KAMIRA AVENUE VILLAWOOD

RFI - URBAN DESIGN REPORT

JULY 2023

**KAMIRA AVENUE
VILLAWOOD STAGE 02**

COMMUNAL OPEN SPACE
CALCULATIONS

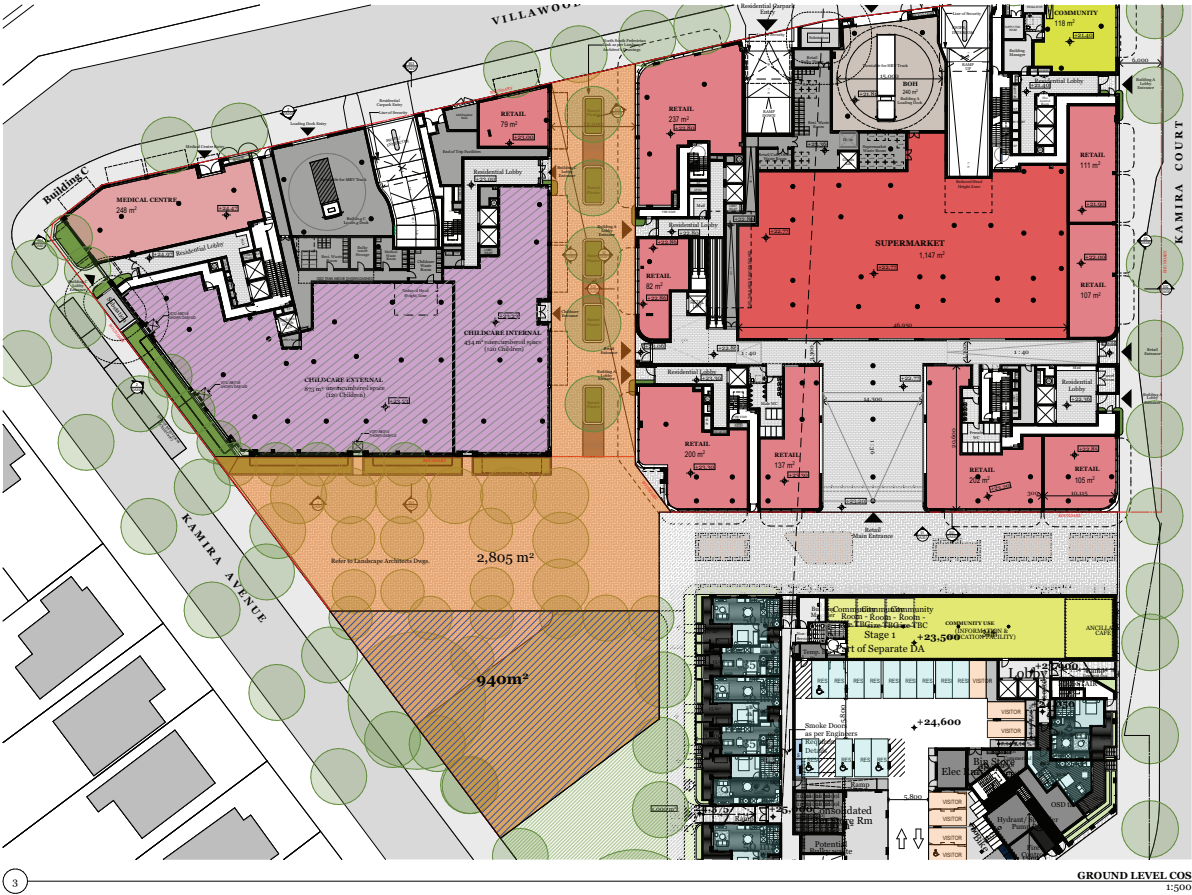
Clause 4.18.2 of the DCP requires the development to provide a communal open space with an area equivalent to 30% of the site area or 200m2 (whichever is the greater) on the podium level in one contiguous area. Assessment of the application revealed that the total COS area equates to 25% of the site area. Consideration shall be given to providing additional communal open space to facilitate a wide range of outdoor recreational uses and provide a high level of amenity for residents. Furthermore, additional deep soil zones shall be provided on the podium COS as well as terraces, vistas into courtyards from the public domain to provide further variety.

Communal Open space has been recalculated to equate to 30% which exceeds the minimum ADG requirement of 25%. As per the ADG the public land use within the site can be counted towards communal open space.

LOADING AREAS AND WASTE BINS - BUILDING A

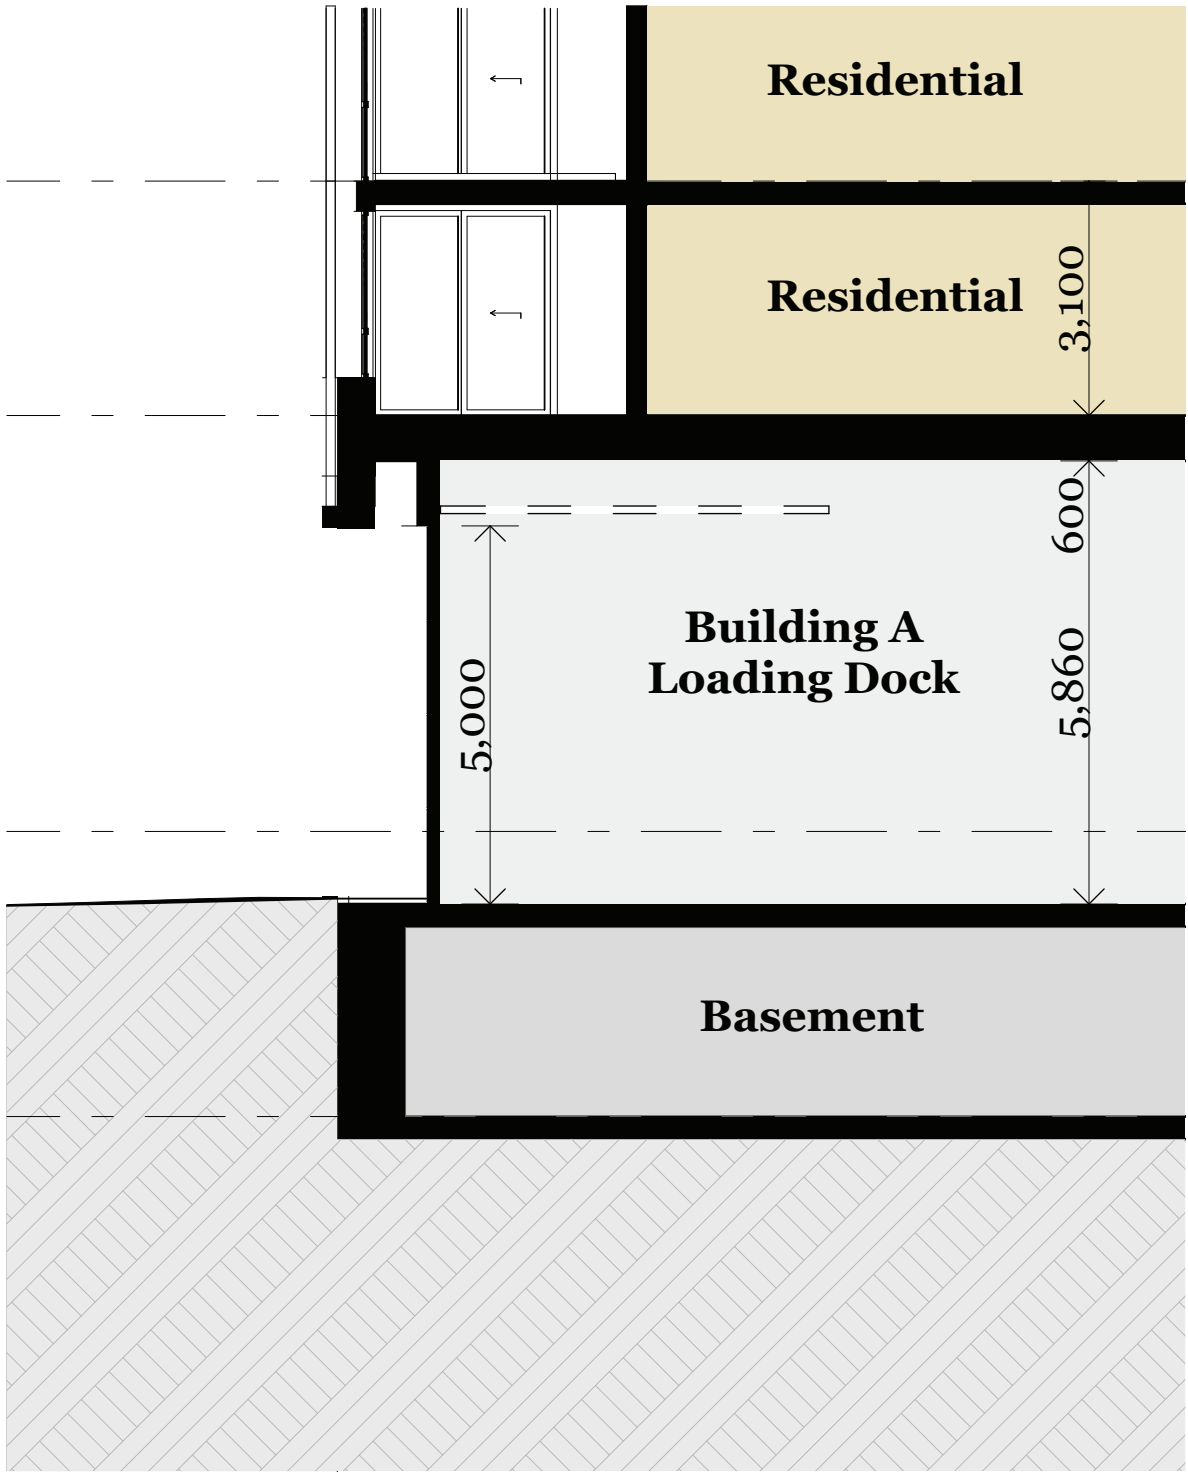
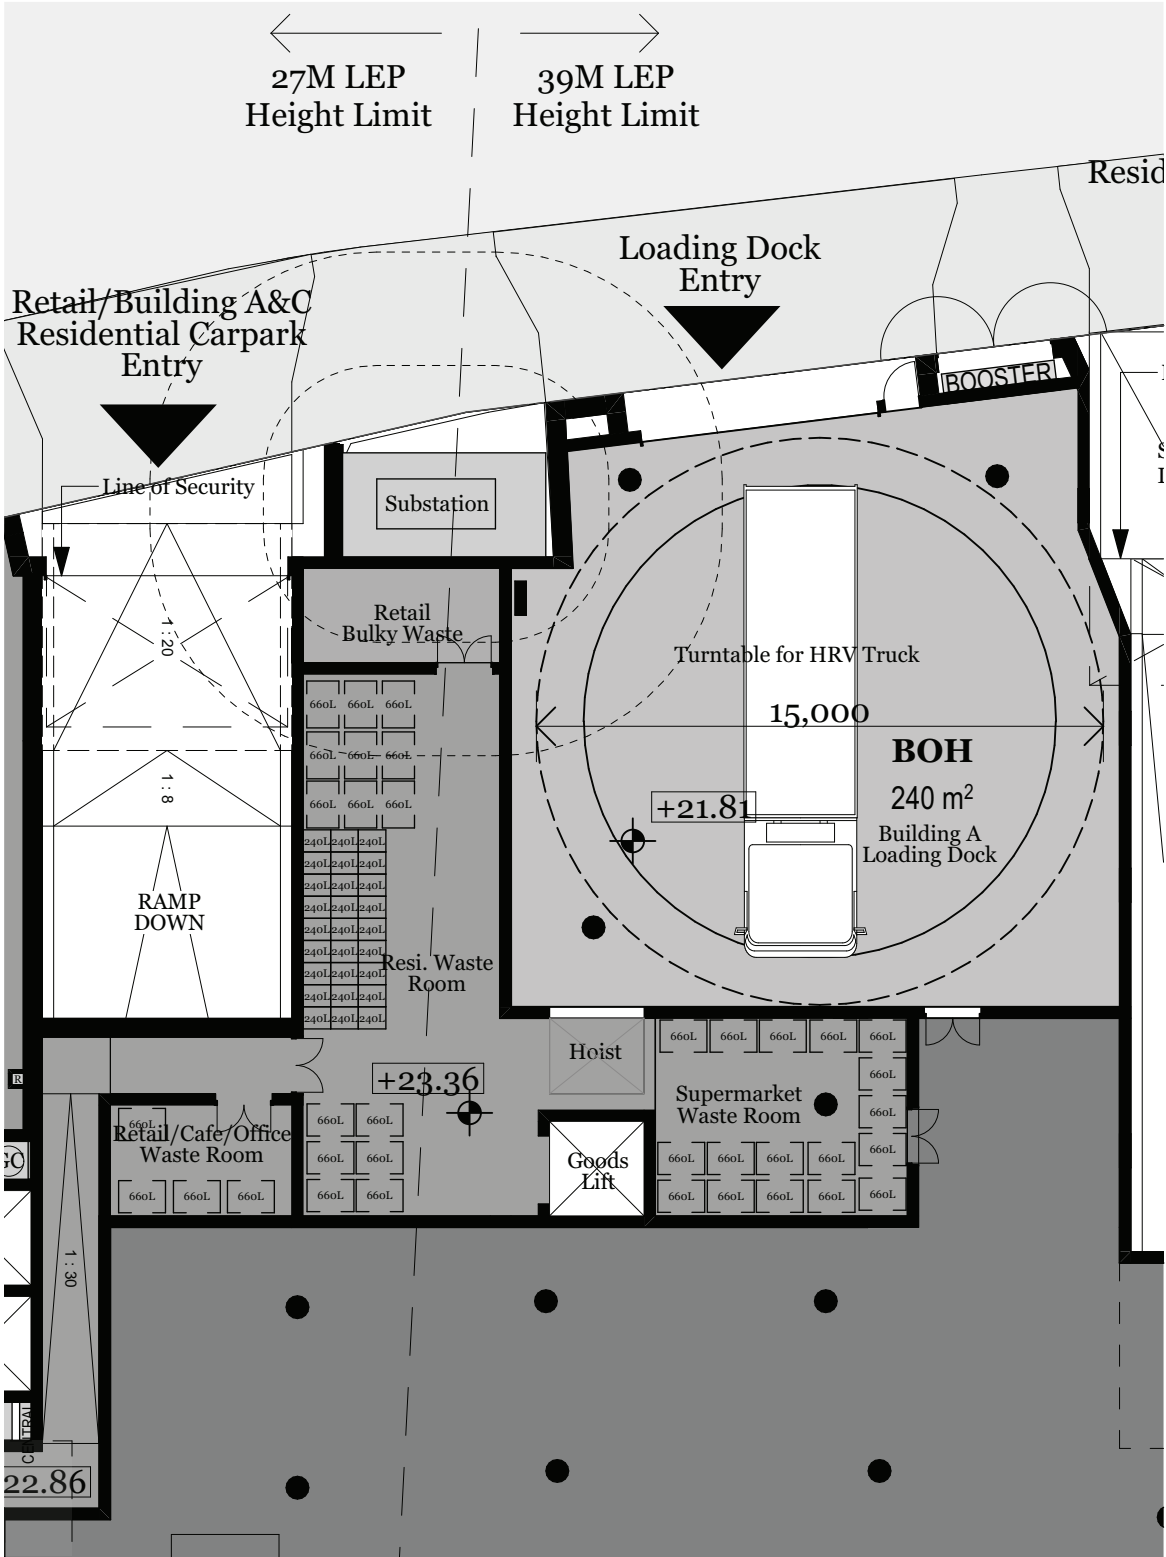
As FCC does not support the use of 1,100L bins, the revised 660L bins will need to be rotated a minimum 2x daily for each respective core (West & East).

The architectural plans and on-site loading bay infrastructure shall be updated to accommodate Council's standard HRV in accordance with the height clearance, dimensions, width etc responsive to AS 2890.1.

The current architectural plans do not provide a detailed elevation of the integrated on-site loading bays (Building A & C). The elevation will enable a detailed review by Council to ensure unobstructed height clearances (4.5m) are provided responsive to AS 2890.1 to support scheduled collections

Section has been provided to demonstrate the 4.5 m height clearance to loading dock.

Bins have been updated from 1100L to 660L

WASTE LOADING AREAS AND WASTE BINS

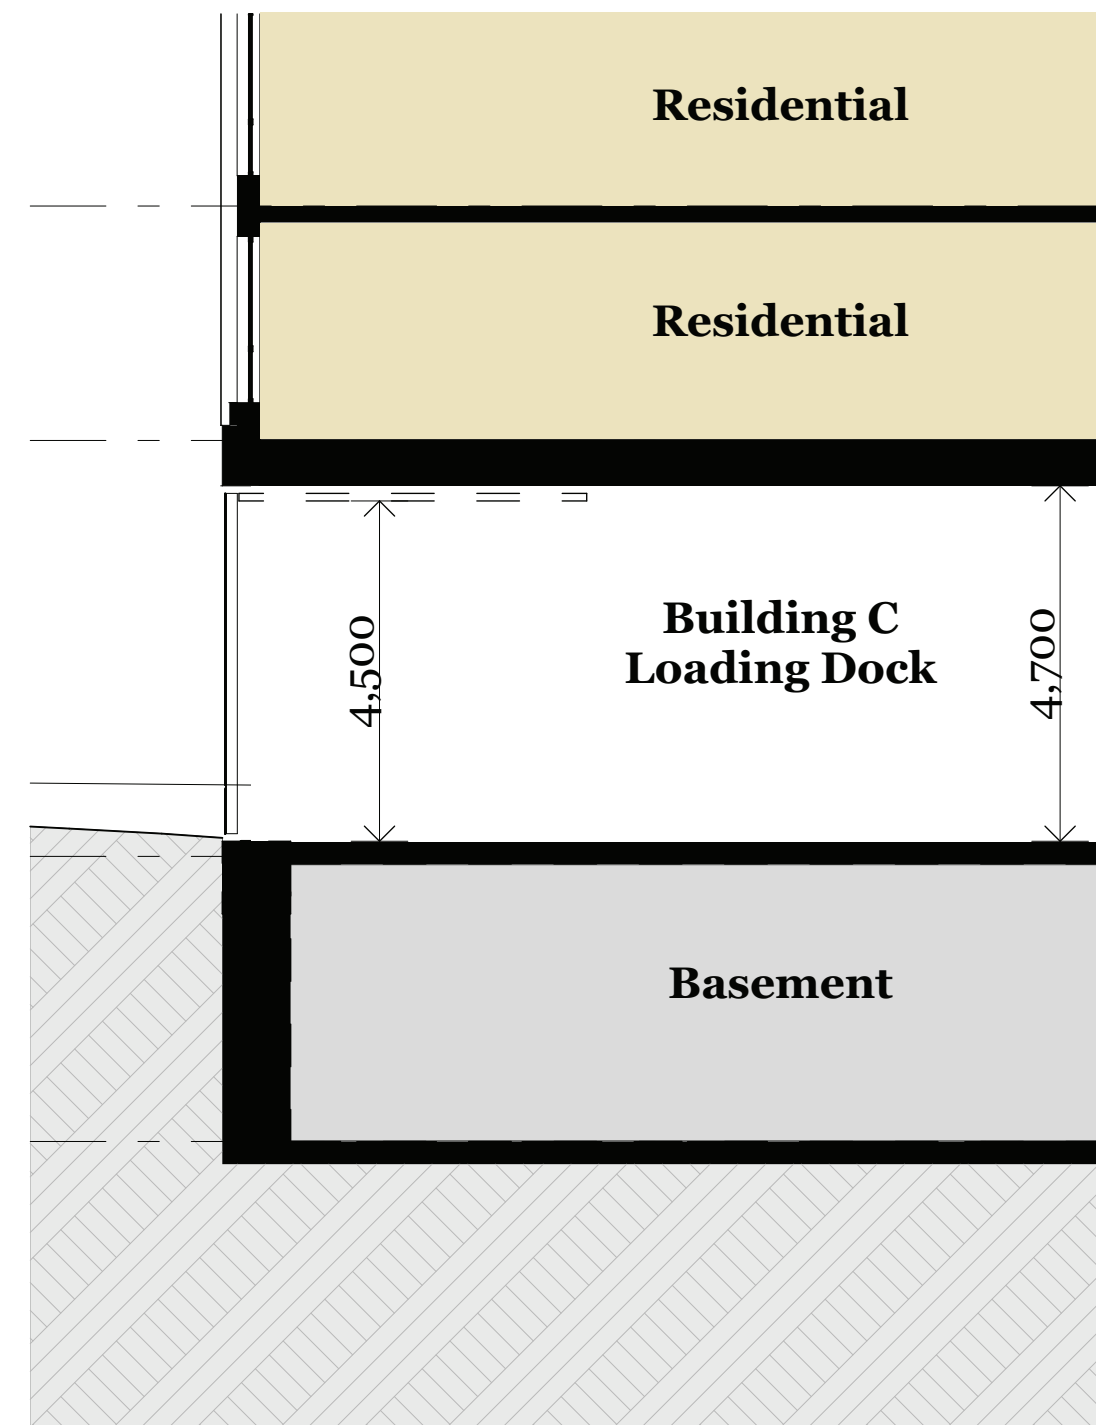
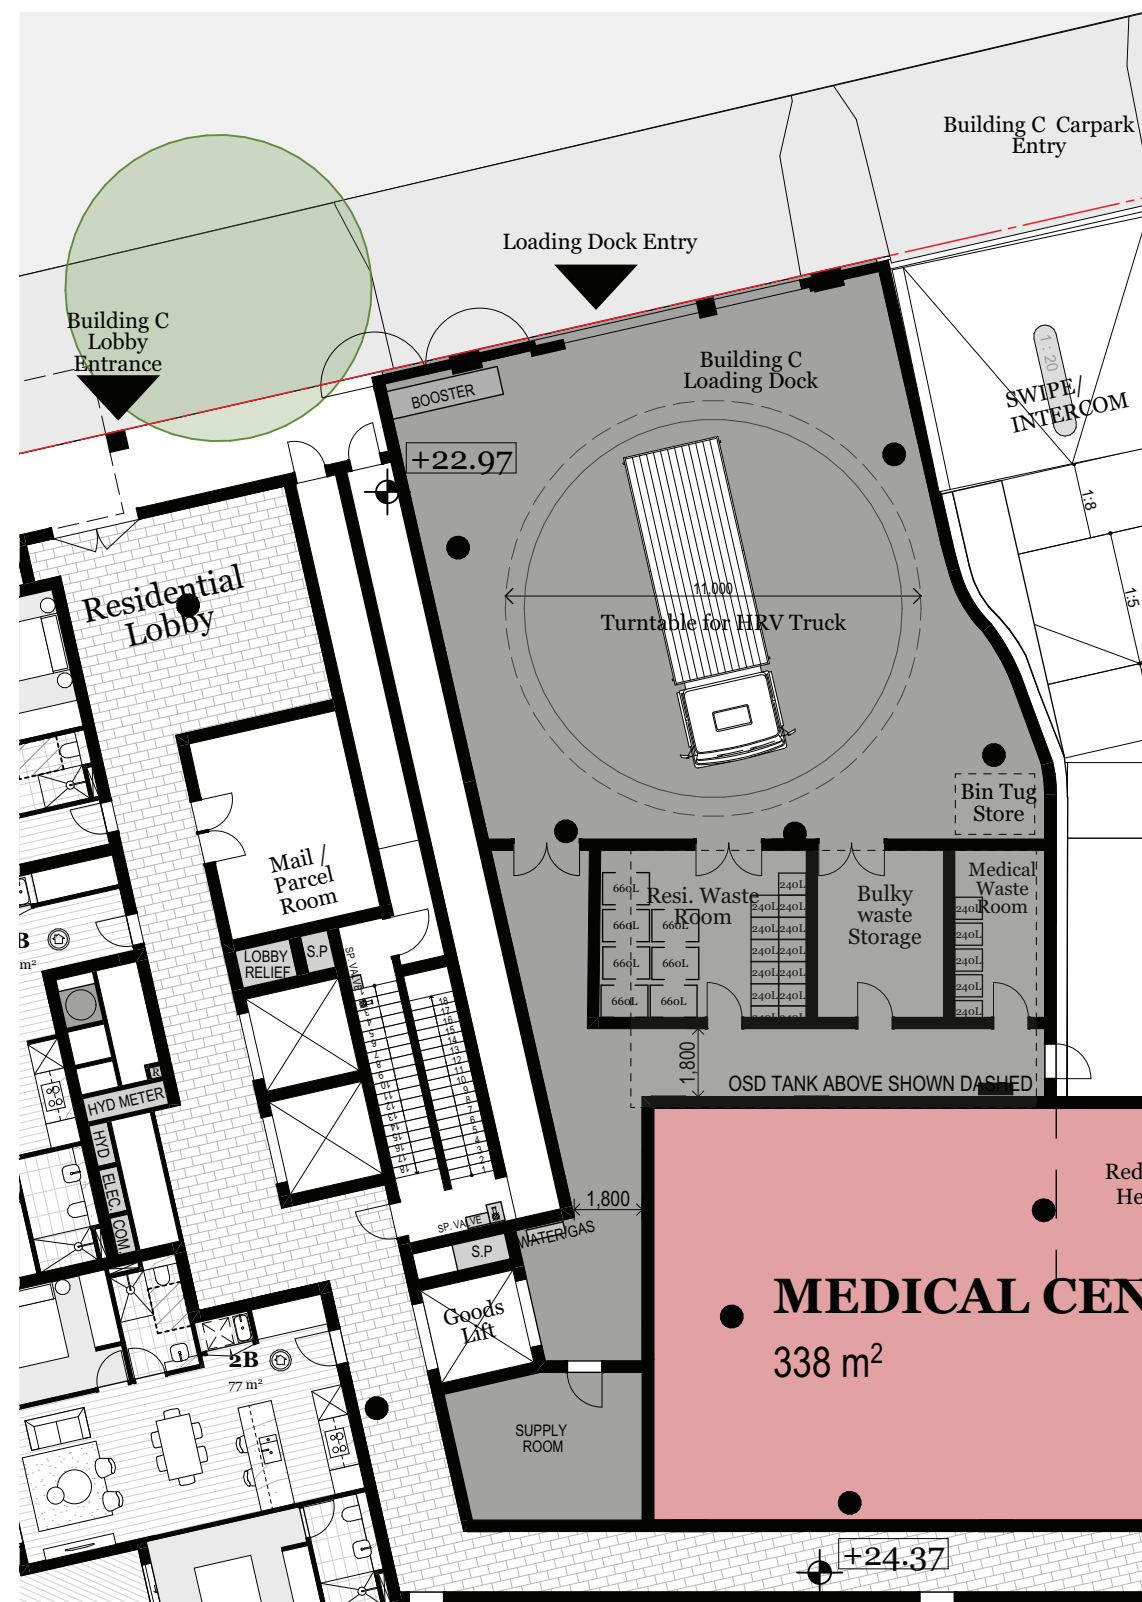
As FCC does not support the use of 1,100L bins, the revised 660L bins will need to be rotated a minimum 2x daily for each respective core (West & East).

The FCC standard waste collection vehicle is a 10.5m HRV used to service residential waste streams (Garbage & Recycling). The current design proposes an 8.8m MRV which will inhibit the provision of a safe and efficient waste collection service.

The architectural plans and on-site loading bay infrastructure shall be updated to accommodate Council's standard HRV in accordance with the height clearance, dimensions, width etc responsive to AS 2890.1.

The current architectural plans do not provide a detailed elevation of the integrated on-site loading bays (Building A & C). The elevation will enable a detailed review by Council to ensure unobstructed height clearances (4.5m) are provided responsive to AS 2890.1 to support scheduled collections

The adjacent waste storage room/s (residential, bulky, medical, childcare) do not support the internal movement of bins from the respective storage room to the integrated on-site loading bay. Unobstructed internal bins access (1100L, 660L & 240L) is required to support the provision of a safe and efficient waste collection service. Consideration shall be given to the implementation of dual doors (1.8m wide opening) on the northern elevations to permit direct access to the service vehicles.

Direct access had been provided from loading dock to each respective storage room

Section has been provide to demonstrate the minimum height clearance to the loading dock are achieved.

Bins have been updated from 1100L to 660L

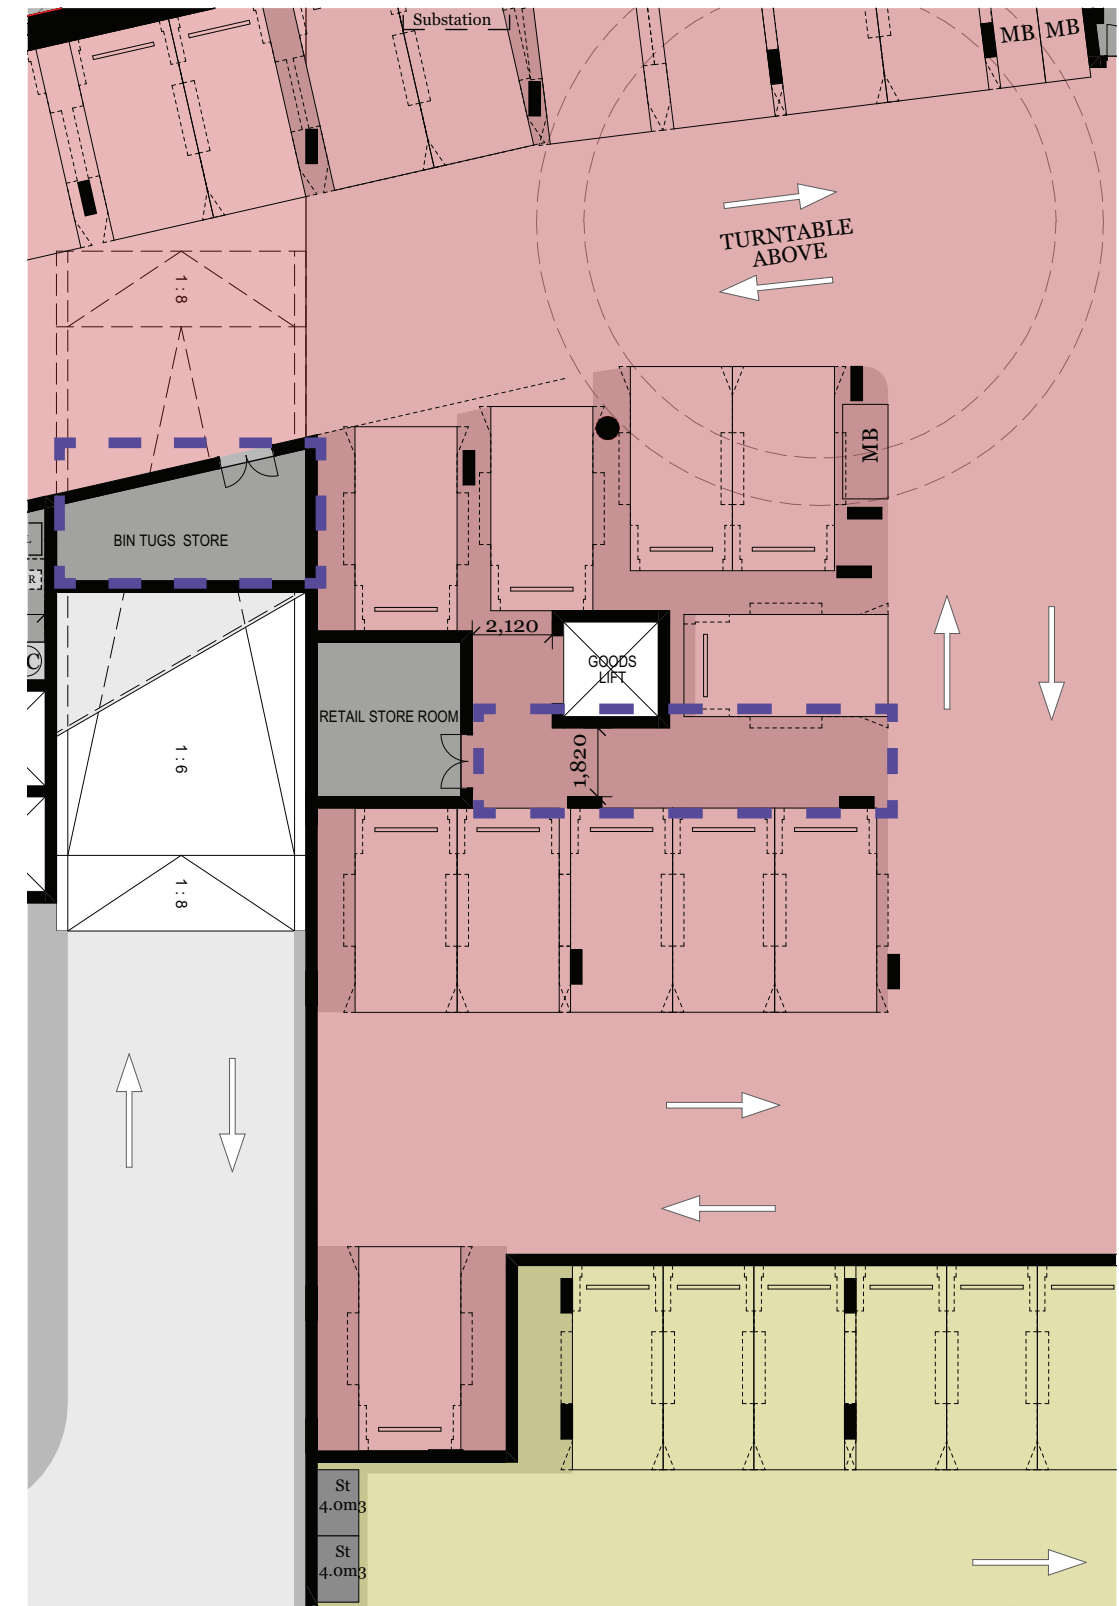
The 'goods lift' located within Basement 1 shall be accessed via a 1.8m unobstructed access corridor. The current arrangement proposes 'MB' parking within the corridor inhibiting access. It is noted the WMP proposes a 'bin tug/trailer' to support bin movements.

All accesses and corridors of Building A & C are sufficiently sized for the safe and efficient use of the goods lift all other waste rooms.
